Amendment No. 1

LCRA Transmission Services Corporation

Emerald Grove Solar, LLC

**FIRST AMENDMENT TO
ERCOT STANDARD GENERATION INTERCONNECTION AGREEMENT**

Exhibit "C2"
One Line Diagram – TSP Interconnection Facilities, Generation Interconnection
Facilities and the Plant

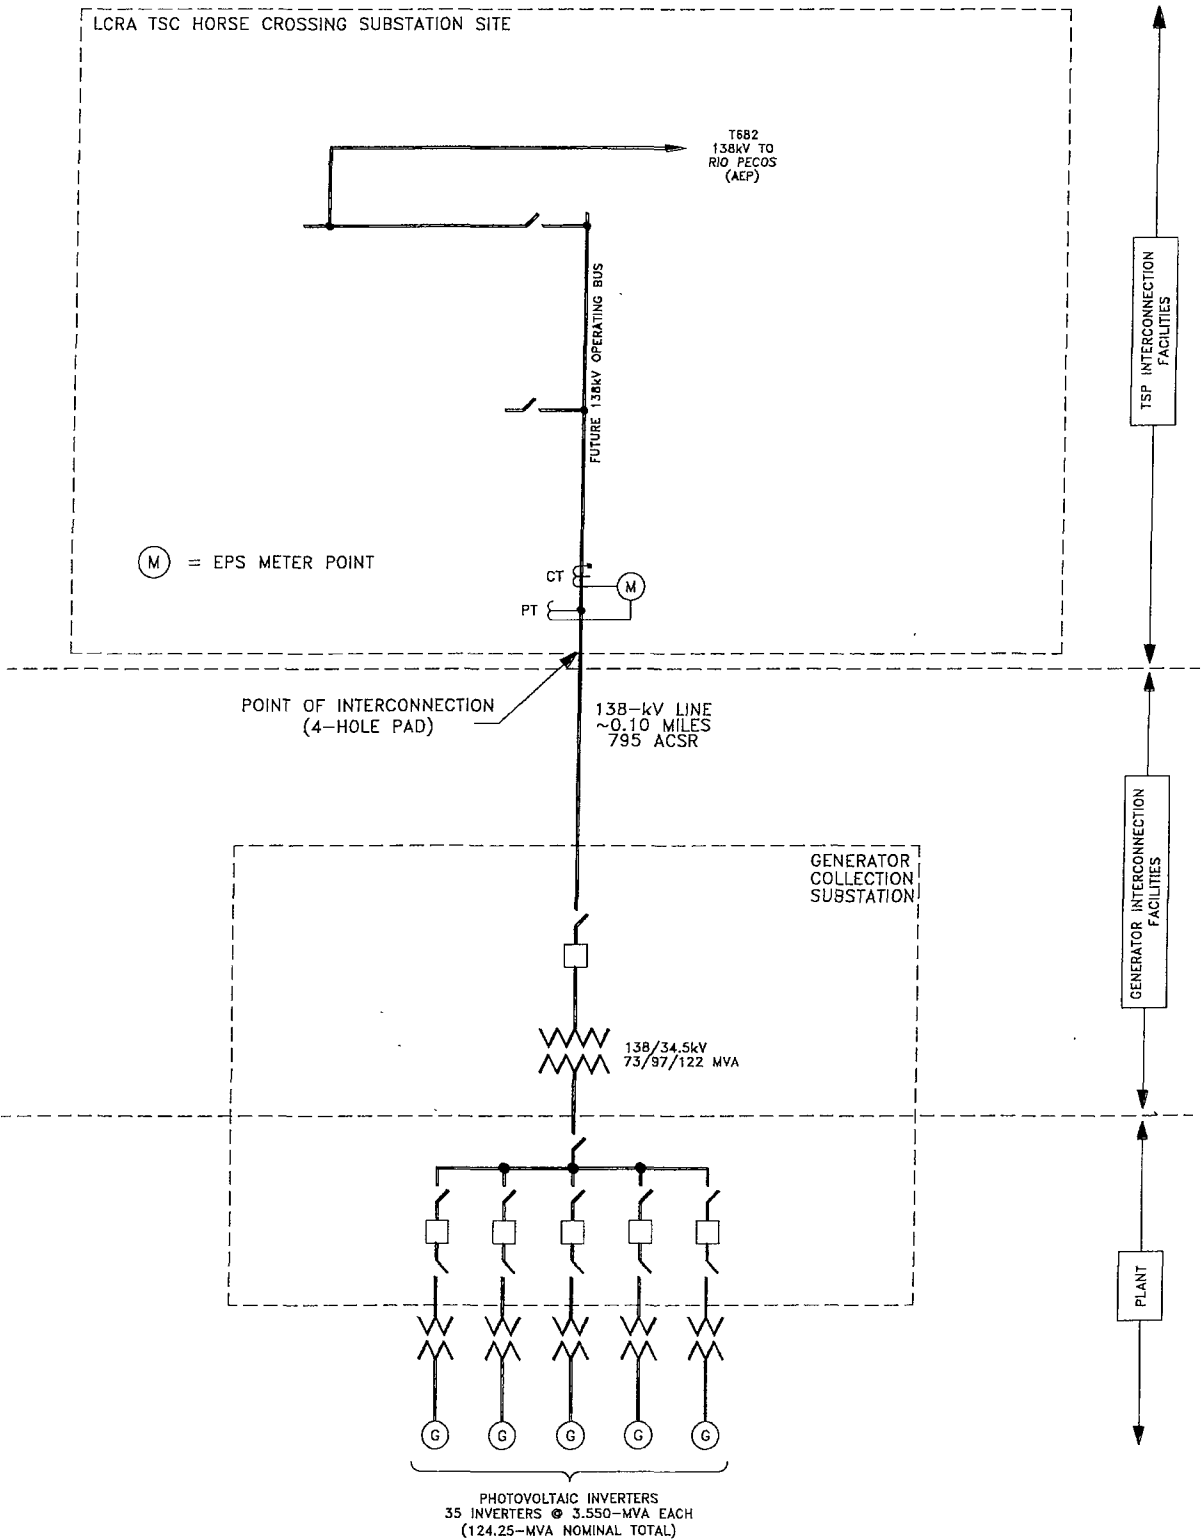
WHEREAS, the Generator notified TSP of a change in the proposed plant design as originally contemplated in the Agreement including a change in the quantity and type of solar inverters.

1. Exhibits "B", "C", "C2", "D" and "E" are deleted in their entirety and the Exhibits "B", "C", "C2", "D" and "E" attached to this First Amendment are hereby added to the Agreement in lieu thereof.

5. Type of Generating Unit: The Plant will be comprised of 35 Power Electronics Model HEM FS3225MU photovoltaic inverters rated at 3.550 MW/MVA at 25°C and 3.225 MW/MVA at 50°C each.
